Staff Summary Report

Development Review Commission Date: 05/22/2012

SUBJECT: Hold a public hearing for a Use Permit and Development Plan Review for ASH PROPERTY RESURRECTION located at 959 South Ash Avenue.

DOCUMENT NAME: DRCr_AshPropertyResurrection_052212 PLANNED DEVELOPMENT (0406)

Site Plan

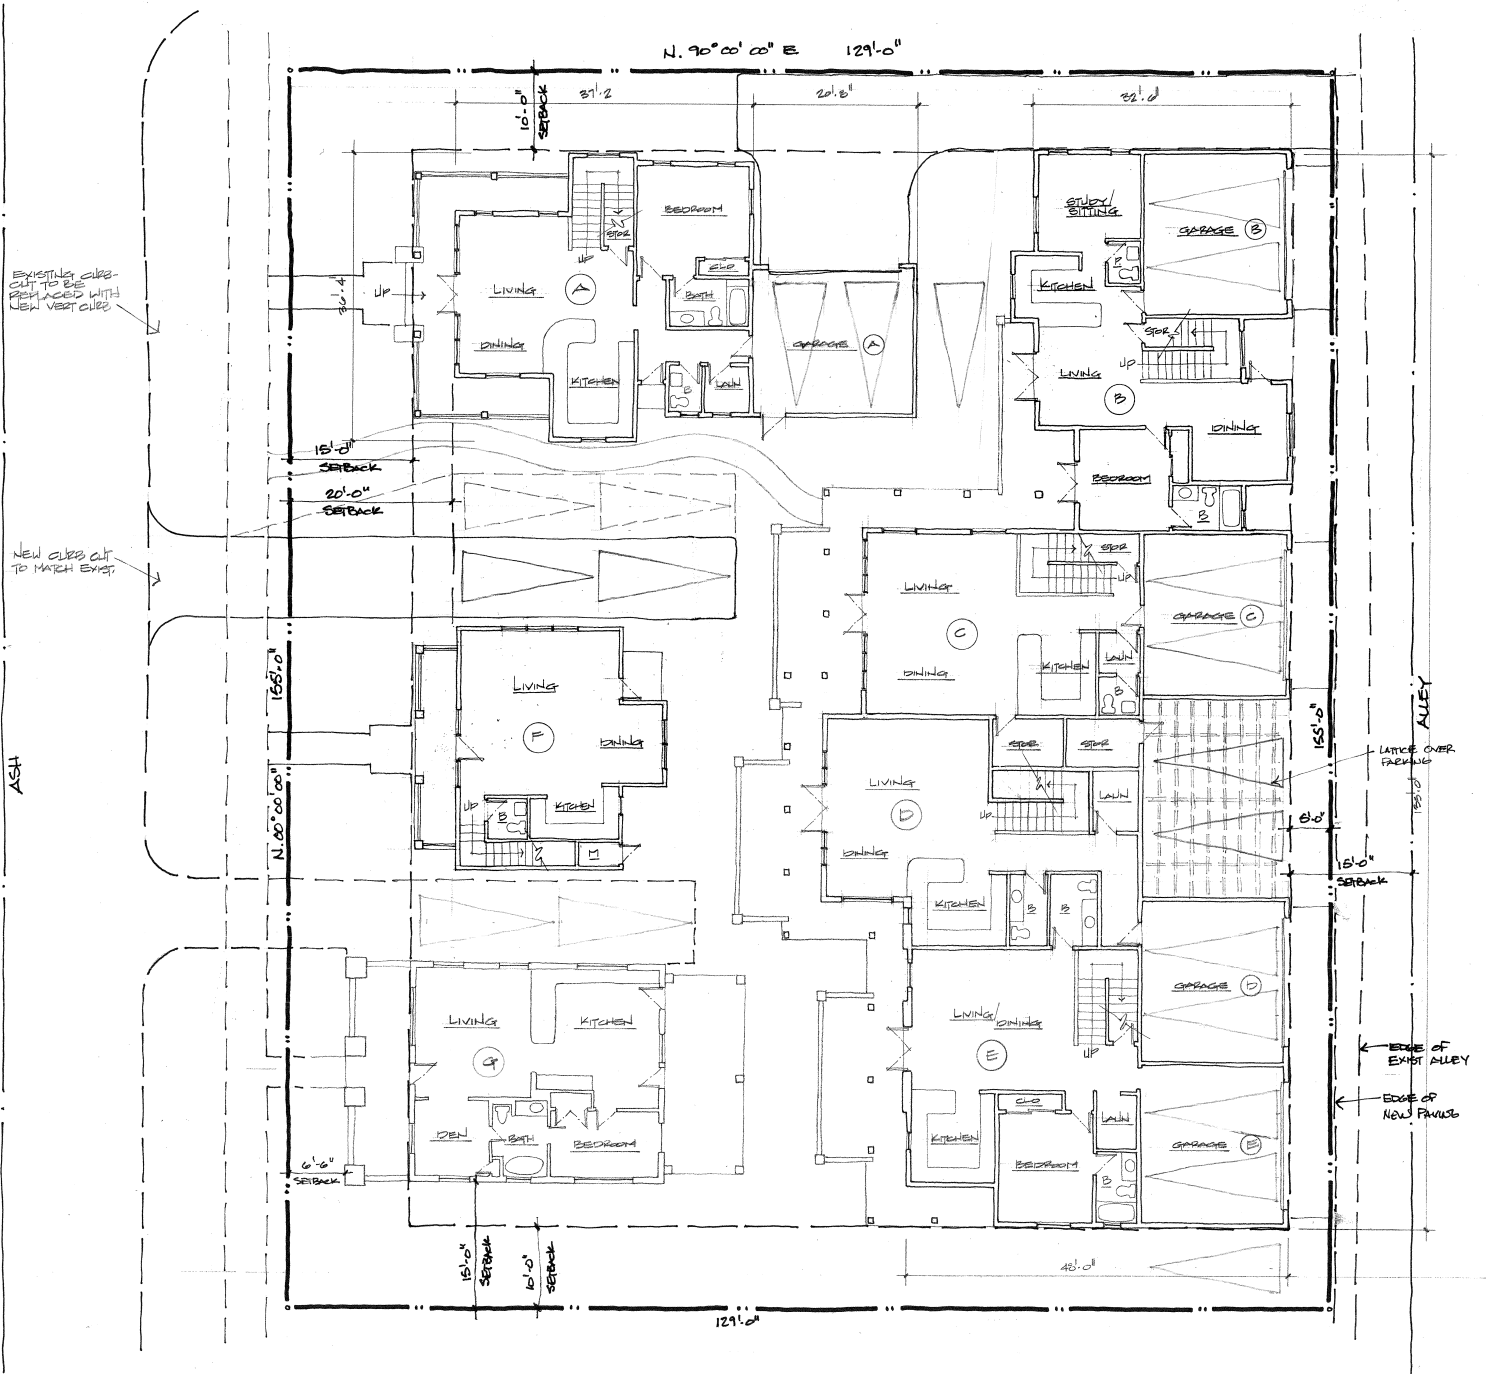
9. Connect tandem parking between Unit A and F to Ash Avenue as follows. Construct a 10'-0" wide concrete driveway on Ash Avenue with quarter round curb returns per Standard Detail T-319. Center driveway on the 17'-0" wide tandem parking pavement. Connect the 10'-0" wide concrete driveway to the 17'-0" wide parking pavement with drive aisle that gradually widens across the width of the 20'-0" parking setback. Provide porous pavement in drive and parking. Do not extend porous pavement into Ash Avenue public right of way.

10. Provide porous pavement for drive aisle from alley to Unit A garage and for drive aisle and exterior parking space between Unit A and Unit B.
11. Provide porous pavement for two space parking and entrance apron between Unit C and D garages. Provide planting areas to north and south of parking and plant vines for overhead trellis.

12. Provide porous pavement for one space parking and drive aisle south of Unit E garage.
13. Provide porous pavement for entrance aprons from public alley to the four Unit B-E garages.

14. Provide raised curbs to define paving and landscape edges and preclude parking in landscape areas.
15. Do not place exterior parking spaces as proposed in retention basins.

16. Do not modify natural grade as proposed under canopy of existing mature oak tree near northwest property corner.
17. Position required bicycle parking as indicated on landscape plan.

- PARKING SPACES:
 - Provide minimum 23'-0" backup from north edge of driveway to Unit 'A' garage door and to exterior parking space between Unit A and Unit B to allow back-up maneuvering per ZDC Table 4-606(A).

- Provide minimum 23'-0" backup from east edge of public alley to exterior parking spaces located off alley to allow back-up maneuvering per ZDC Table 4-606(A).

REVIEW OF LOCATION OF STREET ALLEY & PARKING

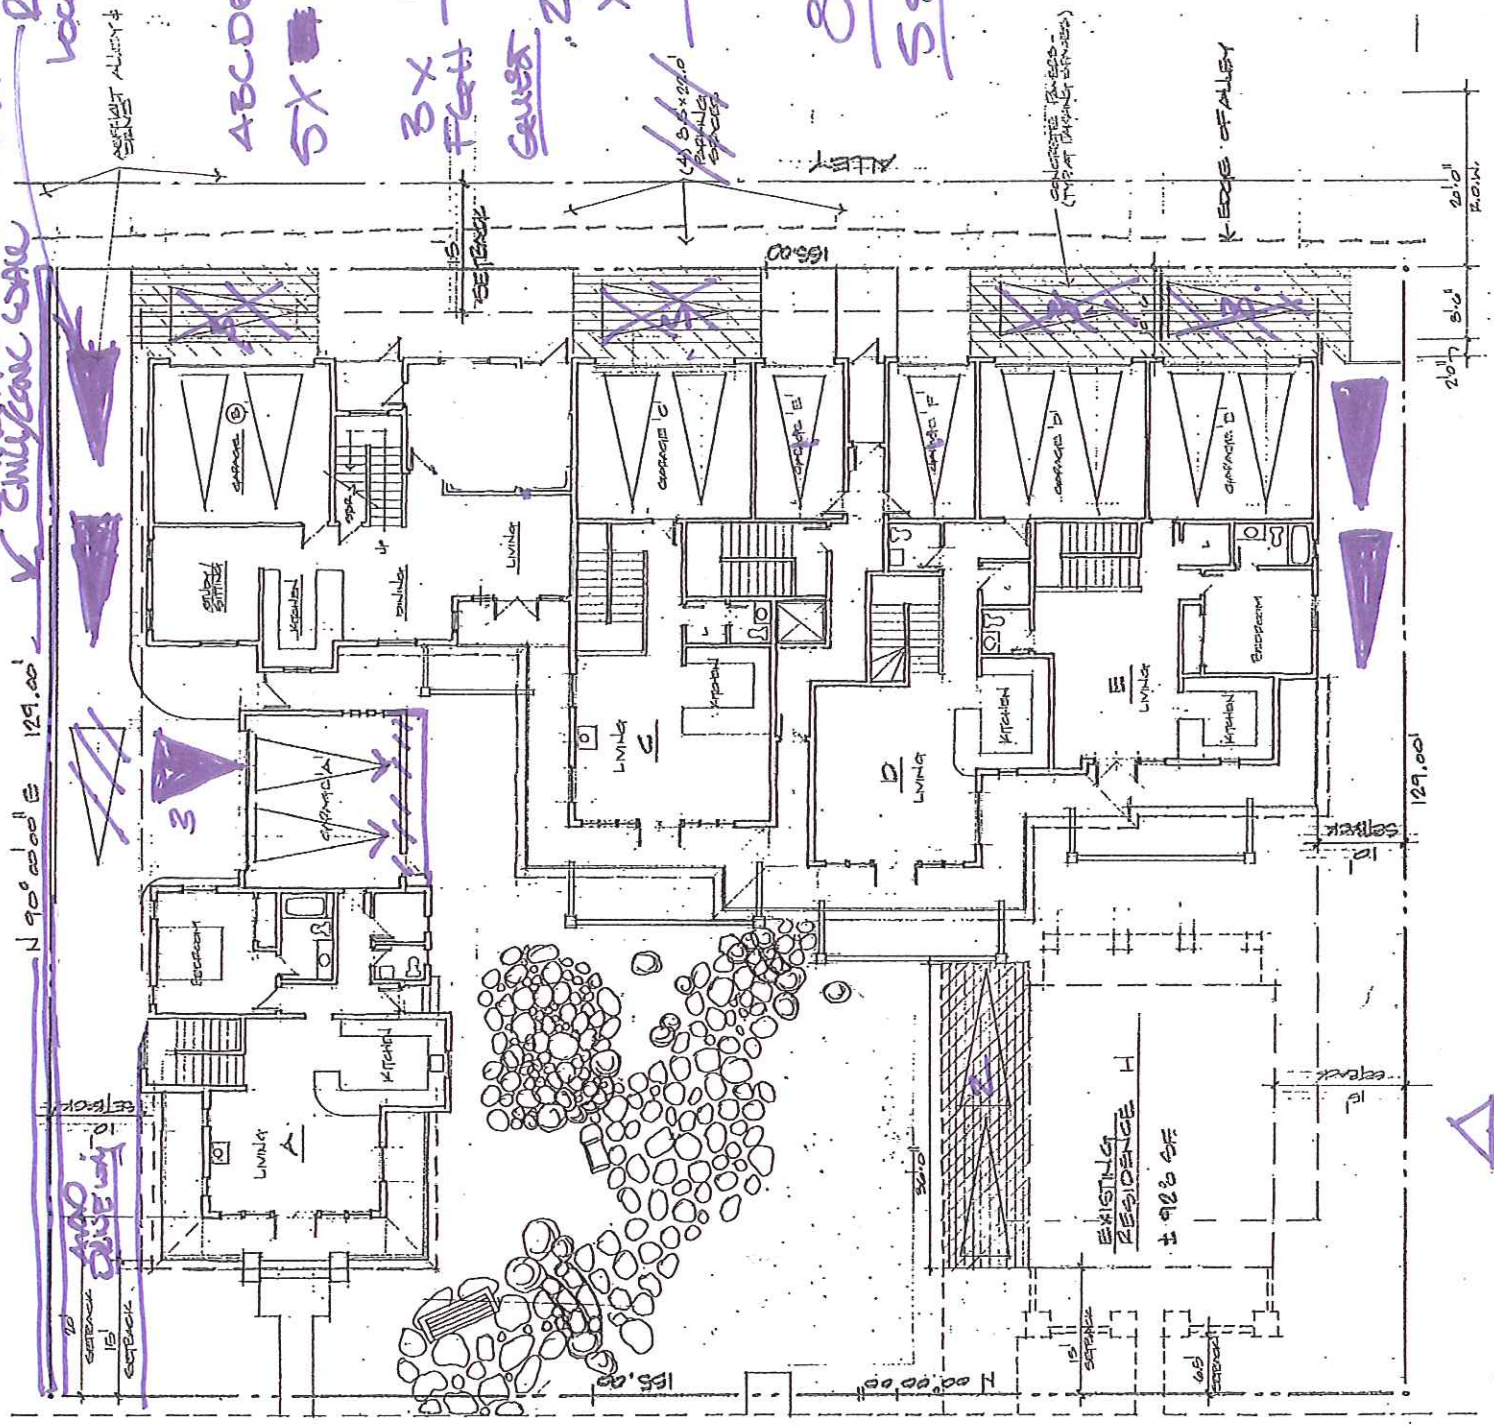
Sienna Court Lofts HOA, Inc. 920 - 936 South Ash Ave. Tempe, AZ 85281
Rhombus LLC 275 West 9th ST Tempe, AZ 85281 (representing 920-932 South Ash properties)
5 attachment pages
